Service Manual

Supplement-2

KX-TC1232JXB

Cordless Answering System

1.3. SCHEMATIC DIAGRAM (HANDSET)

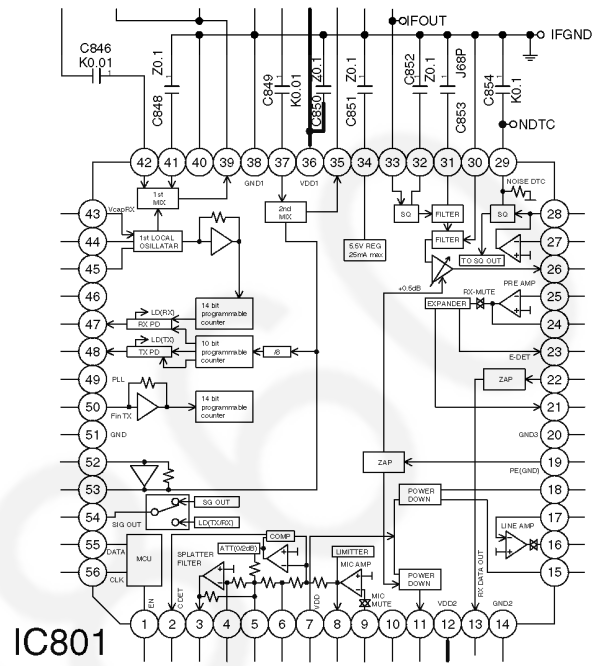
Ref. No.	Part No.		Part Name & Description	Pcs/ Set	Remarks	Notes	Time of Change (Suffix)
	Original (Old)	New					
BASE UNIT							
IC301	C2HBBH000040	C2HBBH000046	IC	1	a	4 V	D→E
	C2HBBH000046	C2HBBH000055	IC	1	a	4 V	E→F
HANDSET							
105	PQGP10189X1	PQGP10222Z1	LCD Panel	1	a	4 V	-
114	PQHX11034Z	PQHX11034R	Pet Sheet	1	a	4 X	-
R831	ERJ3GEYJ751	-----	Resistor, 750Ω	*1 0	a	6 -	-
R832	ERJ3GEYJ152	-----	Resistor, 1.5kΩ	*1 0	a	6 -	-
R903	ERJ3GEYJ184	ERJ3GEYJ154	Resistor, 150kΩ	1	b	1 X	-
ACCESSORIES AND PACKING MATERIALS							
A6	-----	PQQW12671Z	Quick Guide (for Persian)	1	a	5 -	-
